ATLAS IRON WORKS ST. LOUIS, MO.	
Project:	WEBSTER ISB - MOCKUP A'
Customer:	PARIC CDRP
Owner:	WEBSTER UNIVERSITY
Location:	ST. LOUIS, MO
Dwn:	DC
Date:	6/16/16
Ckd:	
Date:	
Job No.	A16013-MU
BAT:	
DWG#:	MUA-E1

PROJECT: 15051-Webster University Interdisciplinary Science Building

RE: Structural Steel Mockup Shop Drawings
REV2

RE: Structural Steel Mockup Shop Drawings

ANCHOR PLAN

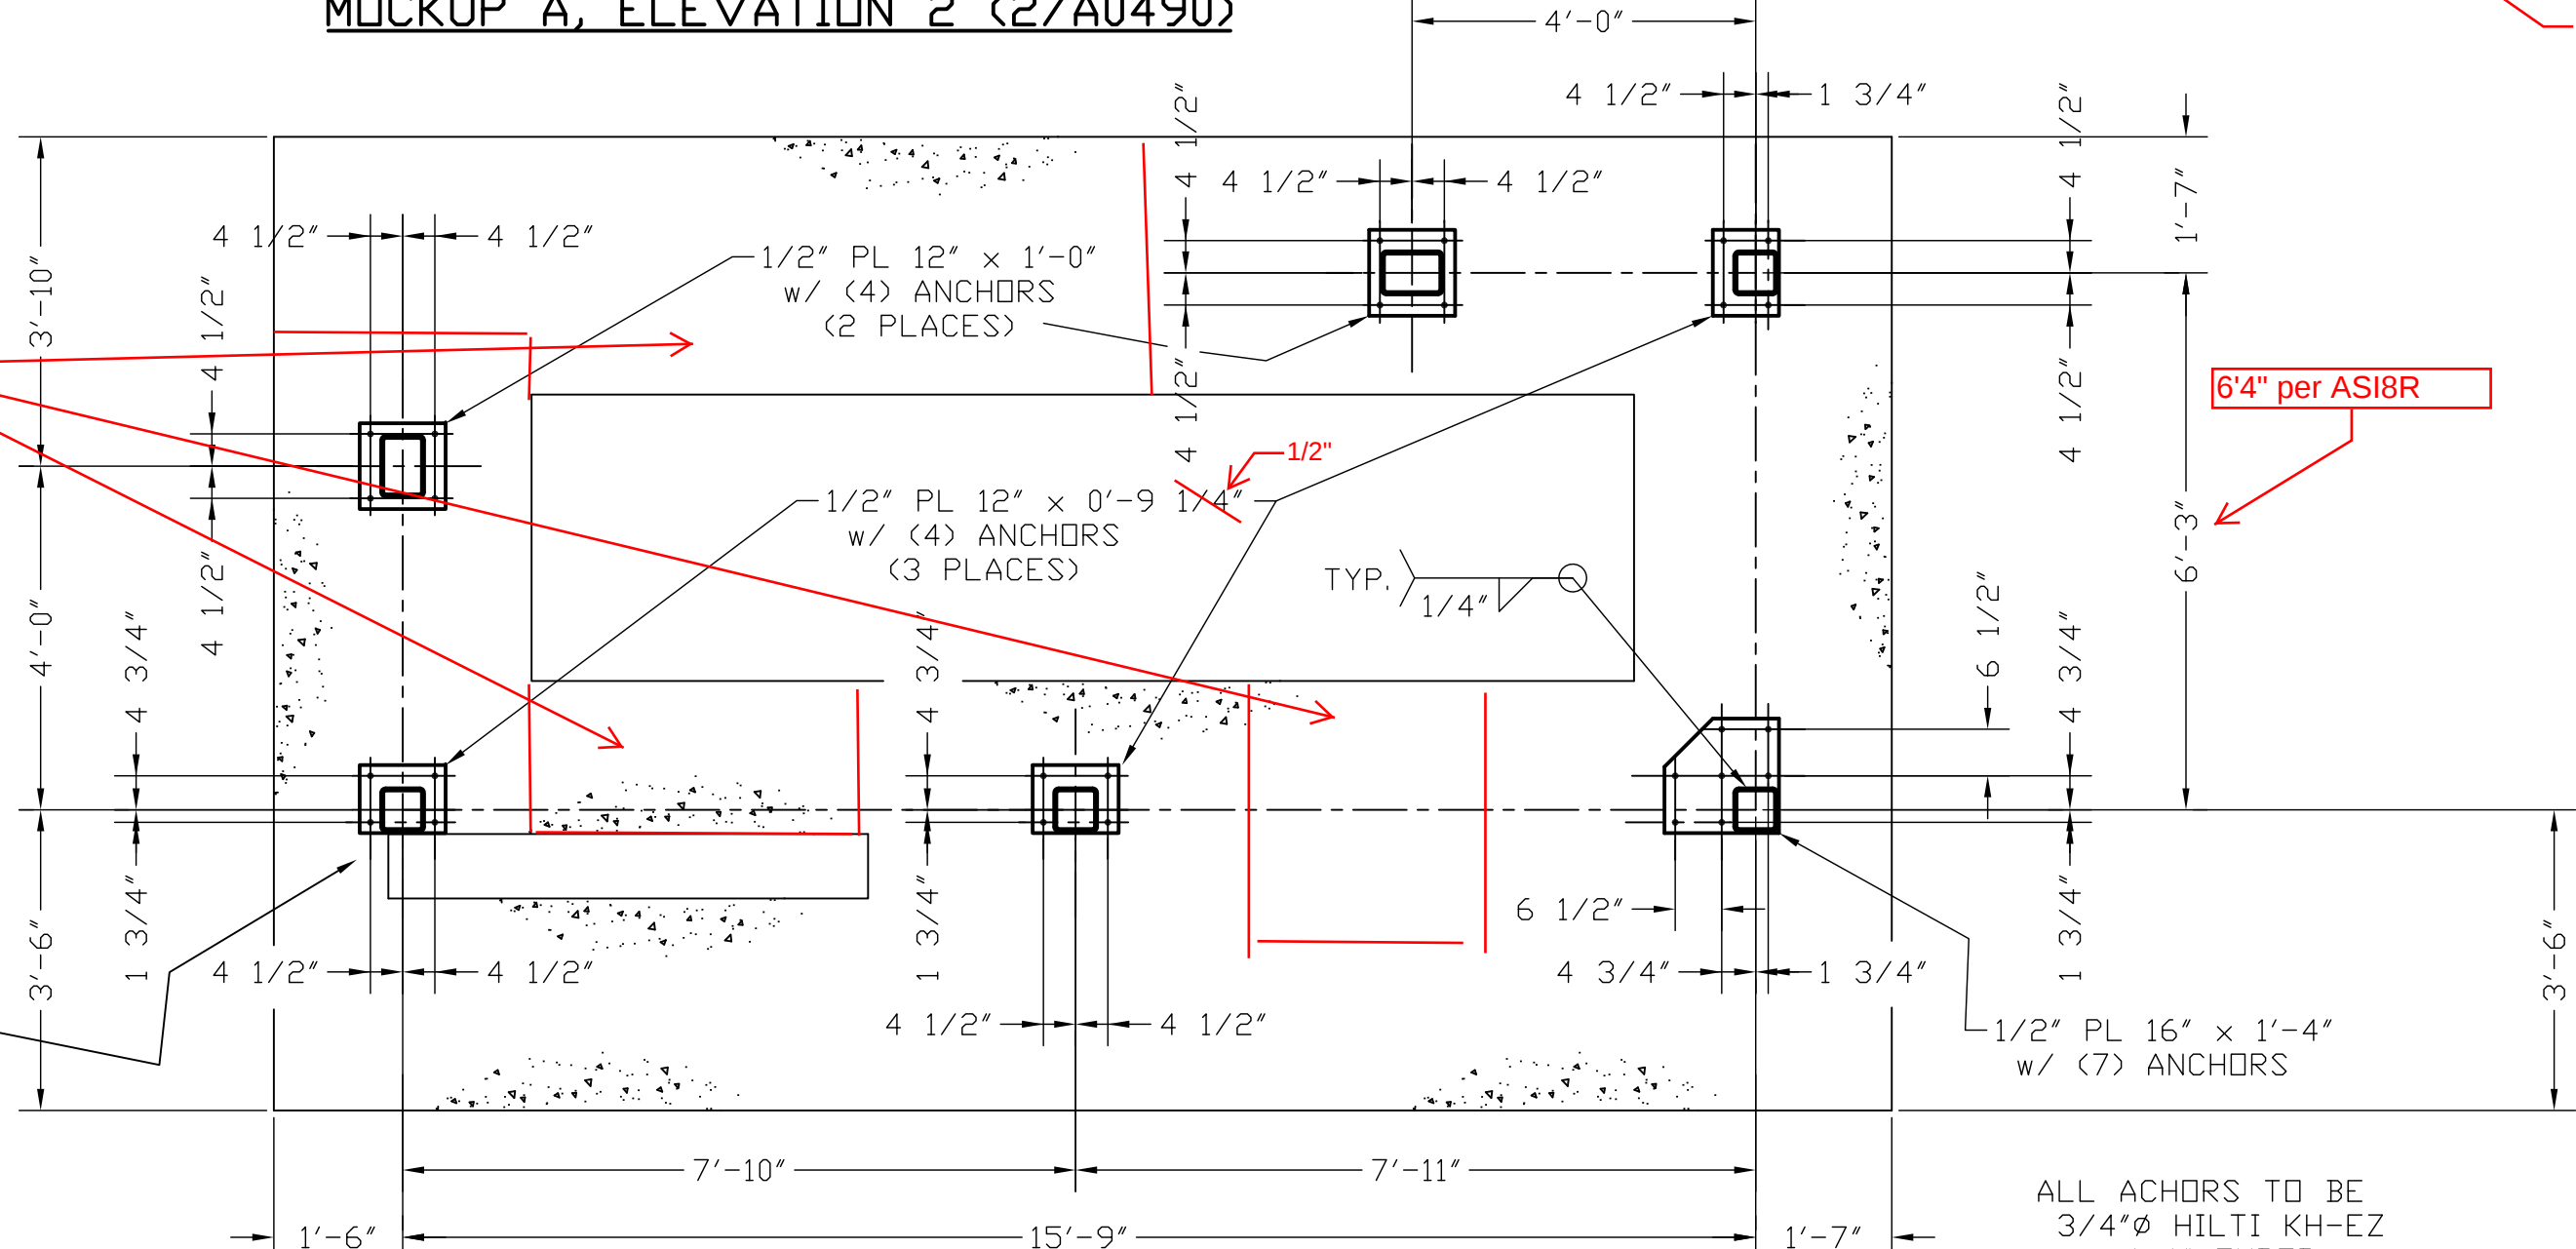
Paric 8/1/16 - Foundation limits have been revised per ASI#8R. Paric will field coordinate the location of steel column placement on foundation. Steel frame configuration remains as originally planned and does not need to be revised on this drawing.
Design Team - please review steel configuration/dimensions

APPROVER!
~ PLEASE VERIFY ANCHOR
EDGE DISTANCE TO CONC
AT THIS COLUMN (1 5/8"?)

Paric 8/1/16 - This is a concrete curb placed onto the strip footing so edge distance should not be an issue. Design team please verify

CORRECT

ANCHOR REQUIREMENTS

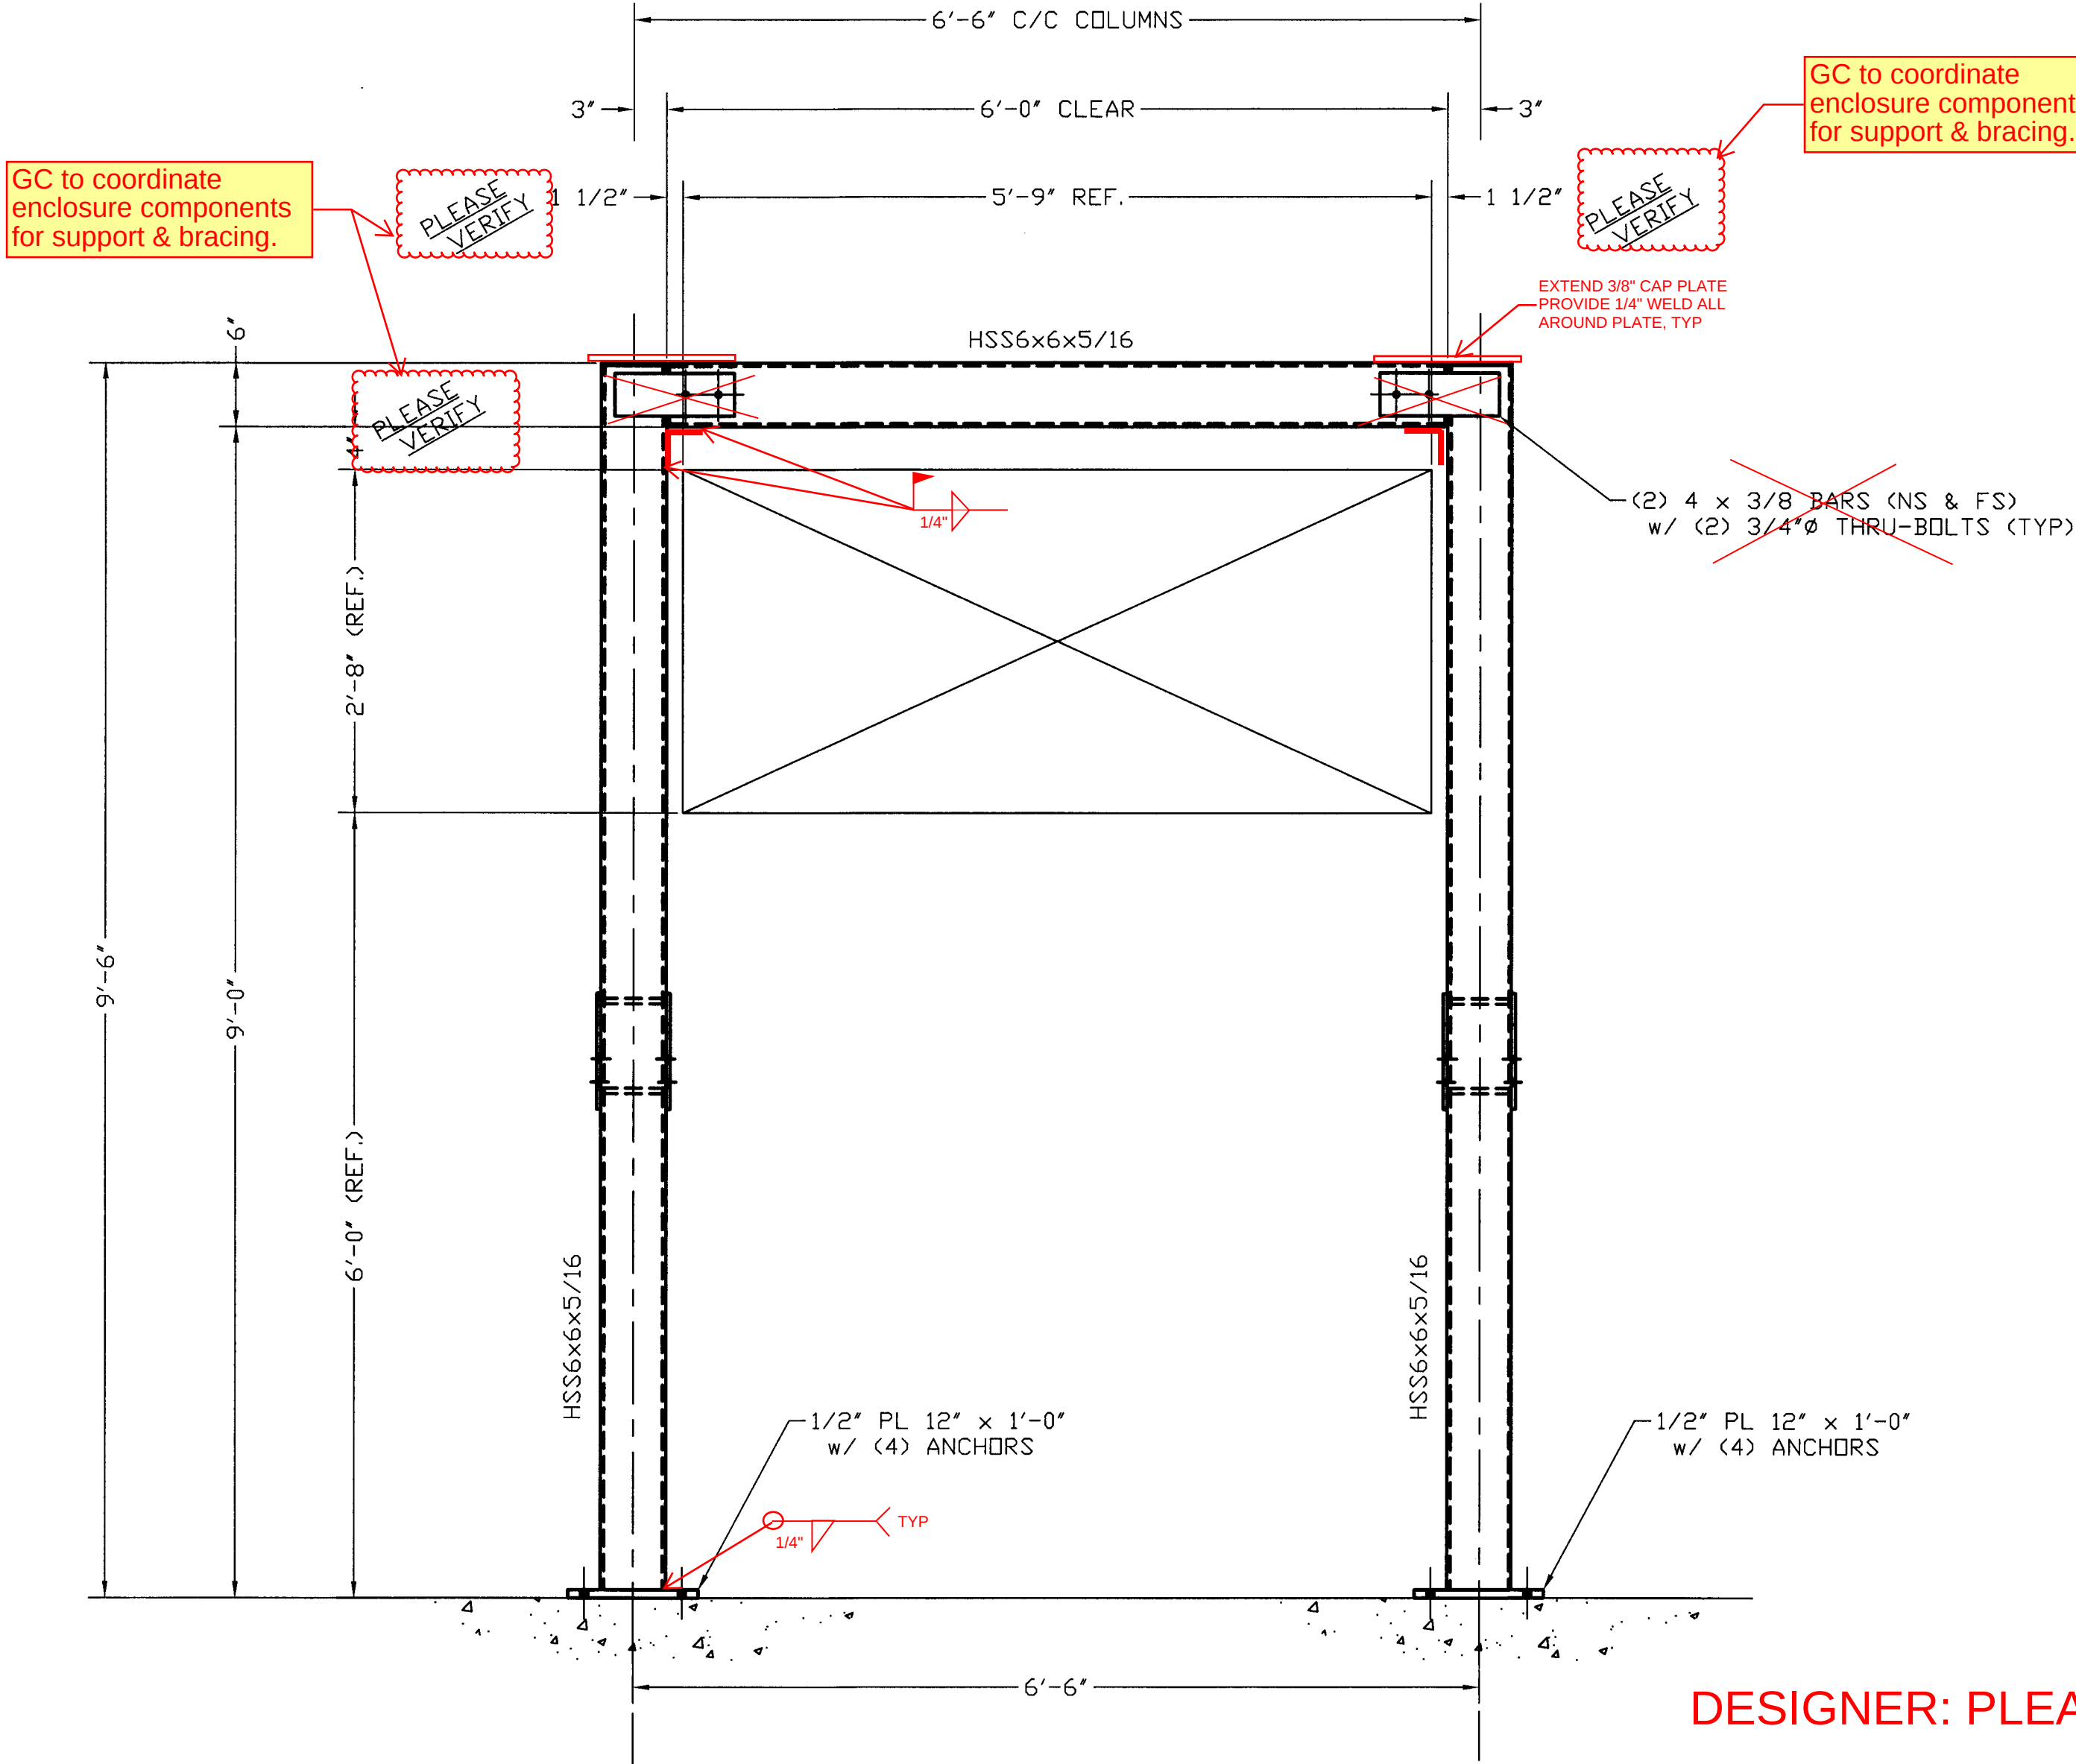
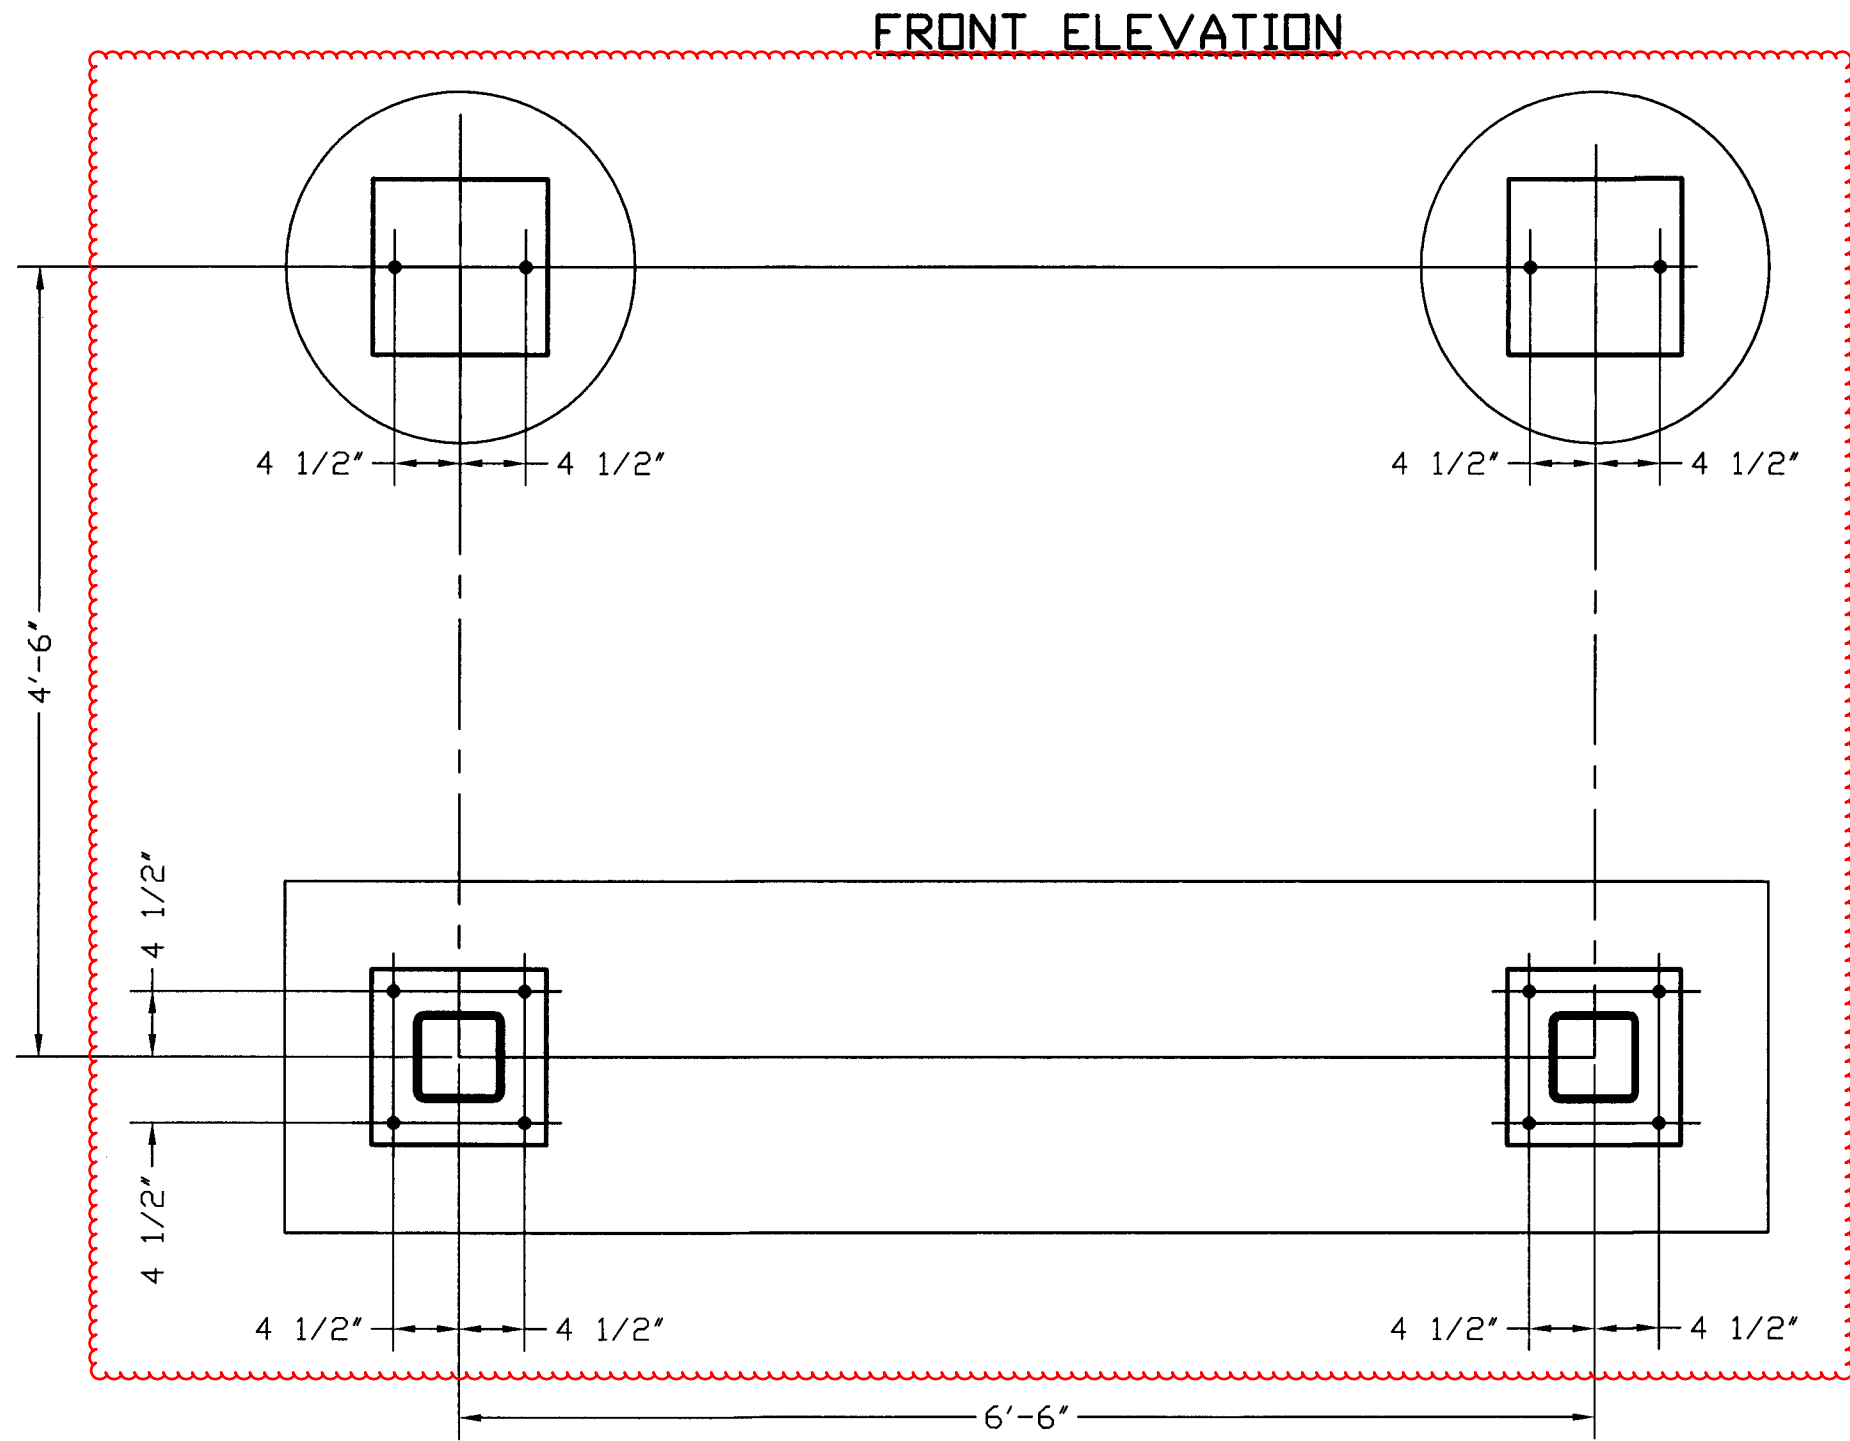
DESIGNER: PLEASE PROVIDE

APPROVER: ~ PLEASE VERIFY DETAILS ~ PLEASE ADVISE ANCHOR DETAILS ~ PLEASE VERIFY GALVANIZED?

PRIME PAINTED STEEL
ACCEPTABLE PER KELVIN PATEL
